ADDENDUM NO. 1

Carmel High School Stadium Phase 3
2440 Smoky Row Road
Carmel, IN 46032

Carmel CH/CHS ACTIVITY STORAGE BUILDING AND BAND TOWER

Addendum No. 1, 8 items, 3 pages
Revised Drawing Sheets: G1.1, G1.2, G4.0, S1.01, S3.02, EL11 and E-601

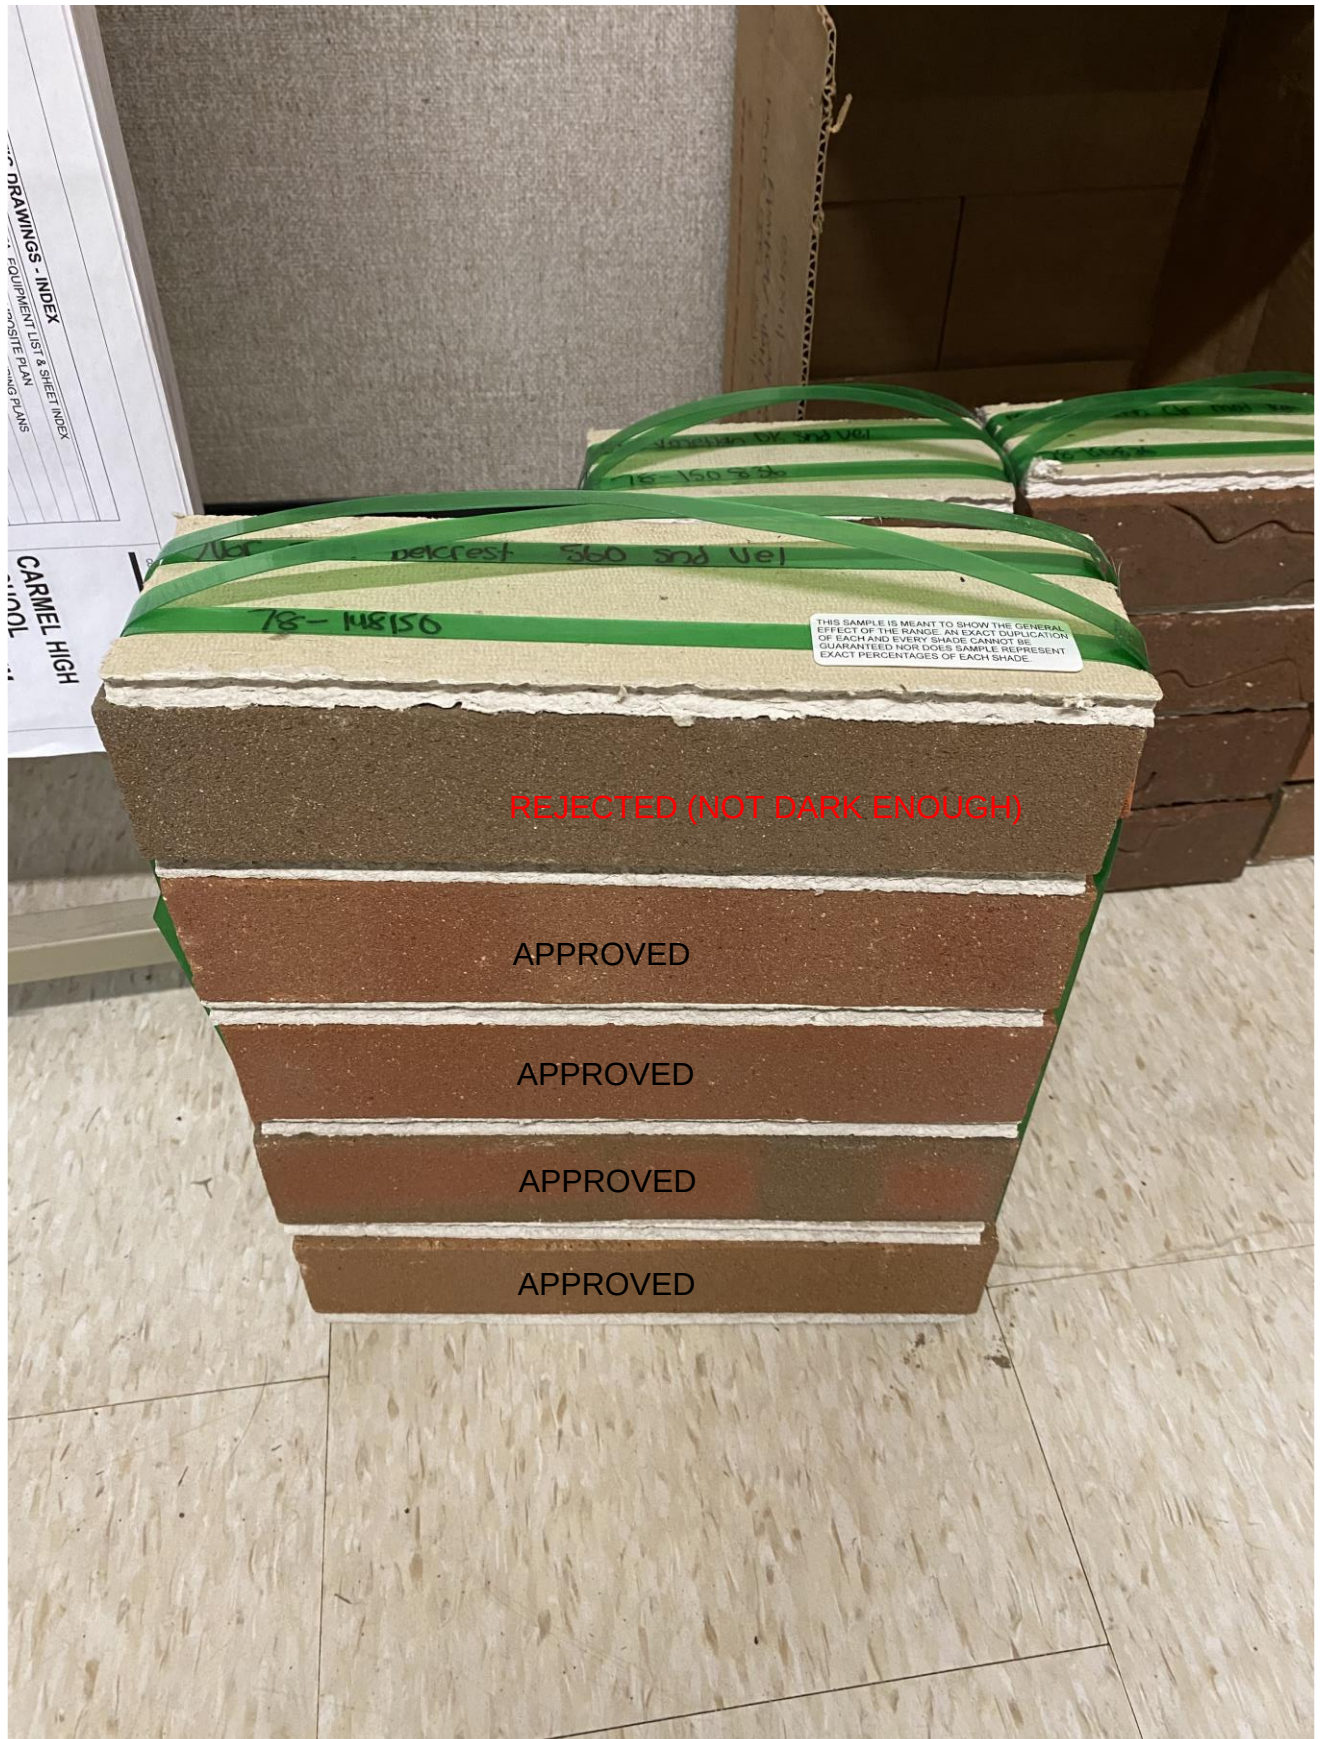
ORIGINAL SAMPLE SELECTION SUBMITTED
(ALL BRICKS APPROVED WITH THE EXCEPTION OF THE TOP DARKER BRICK IN THIS SAMPLE BOARD)

ALTERNATE DARKER SAMPLE SUBMITTED
(APPROVED AS BRICK FOR THE DARKER SAMPLE REJECTED IN THE ORIGINAL SAMPLE BOARD)

G1-1

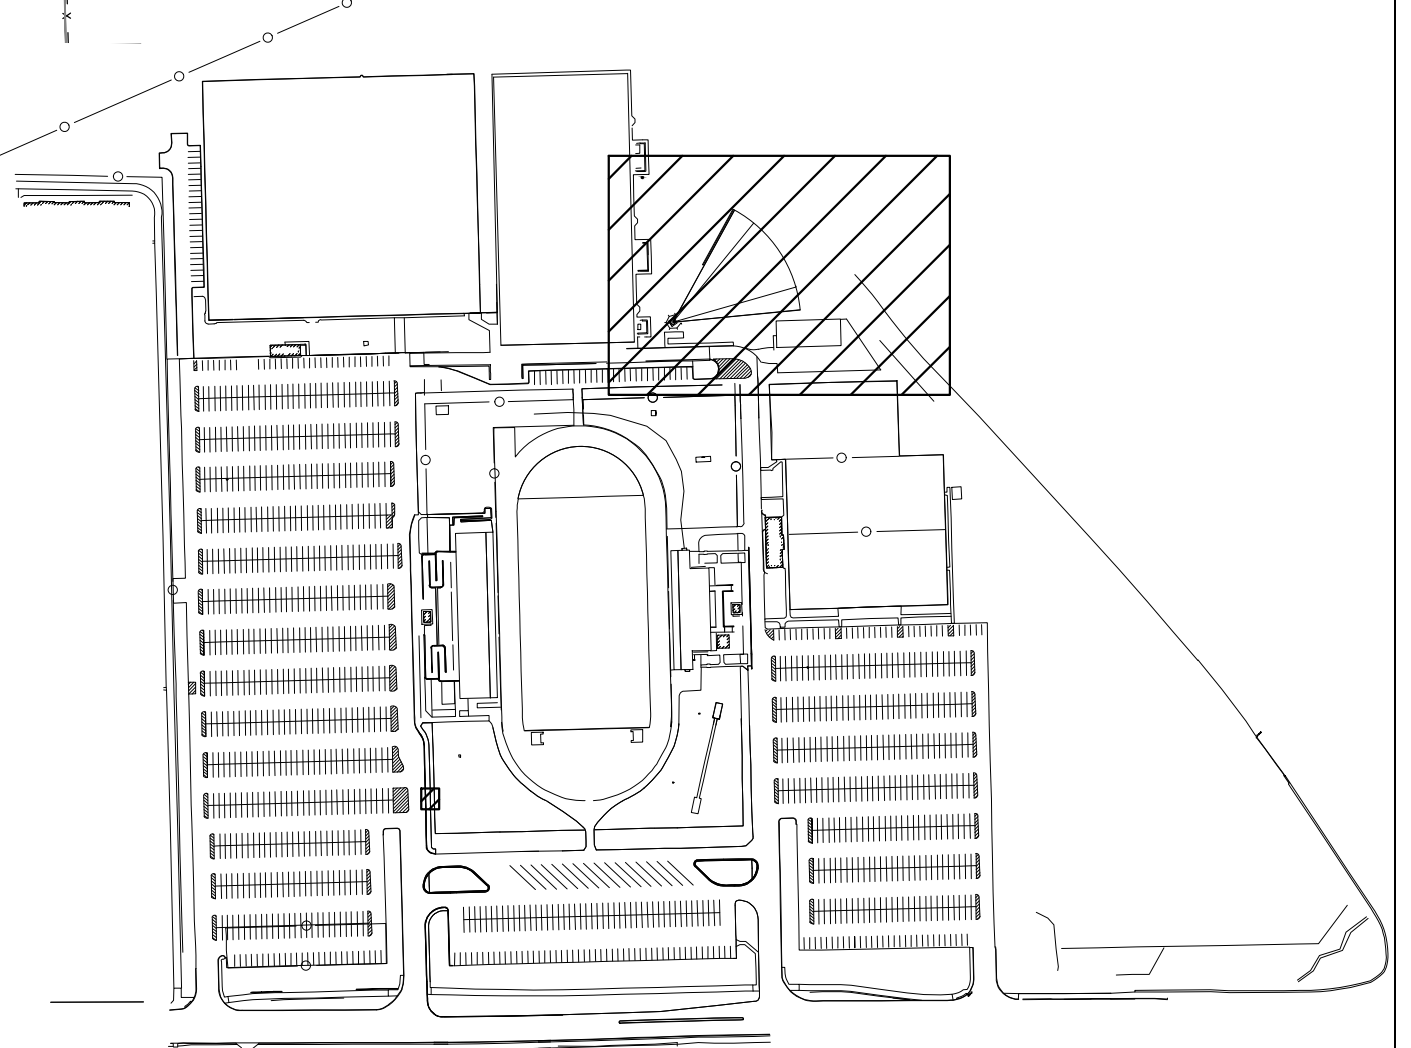
13 ASPHALT PAVEMENT - SEE DETAIL P & Q/G4.0 (ALTERNATE #1 - CONCRETE PAVEMENT PER DETAILS C & D/G4.0)

24 6' HT. BLACK VINYL COATED CHAIN LINK FENCE - SEE DETAIL F & G/G4.1

10. Responsible for matching and extending the existing 4' chain-link fence and mowstrip approximately 70' per plan per plan note 14 and 24. (Fencing is 4' not 6' as plan note mentions)

16. Disregard Note 46 and windscreen. If needed it will be handled outside of this contract.
17. Disregard Section 07 42 13 Metal Wall Panels. The metal wall panels on the band tower should originate from the 13 34 19 Metal Building Systems Spec/Contractor.

Alternate Bid No. 1 – Concrete Paving in place of Asphalt Paving at Storage Building (Note 13 Sheet G1.1)

G1-2

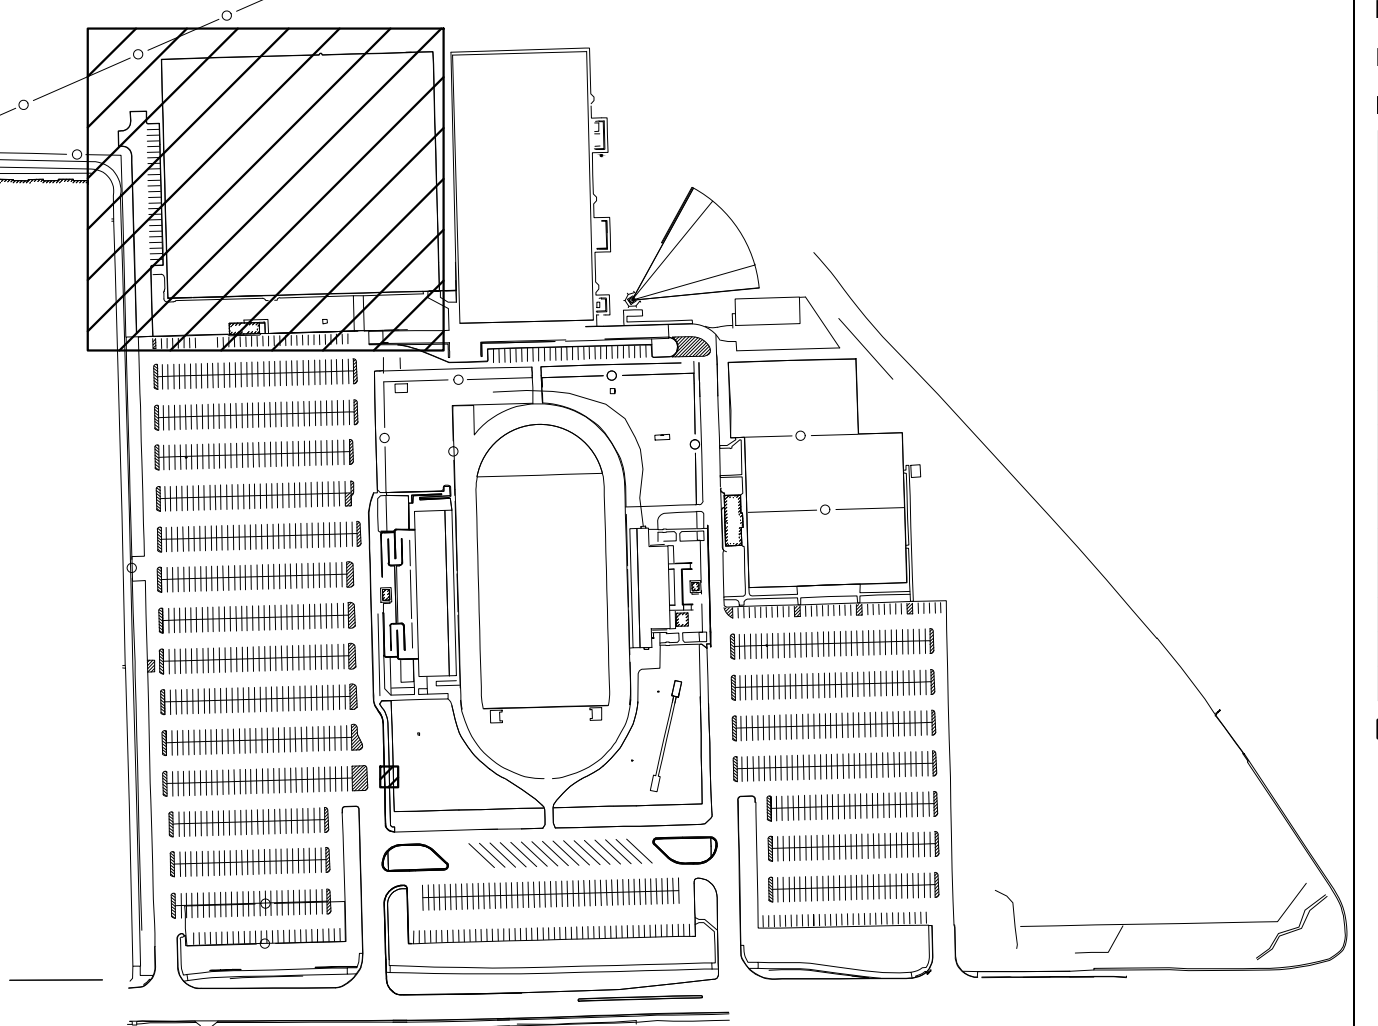
- B. Alternate Bid No. 2 – No Fencing at Practice Fields (Note 4 Sheet G1.2)

Alternate Bid No. 2 – No Fencing at Practice Fields (Note 4 Sheet G1.2)
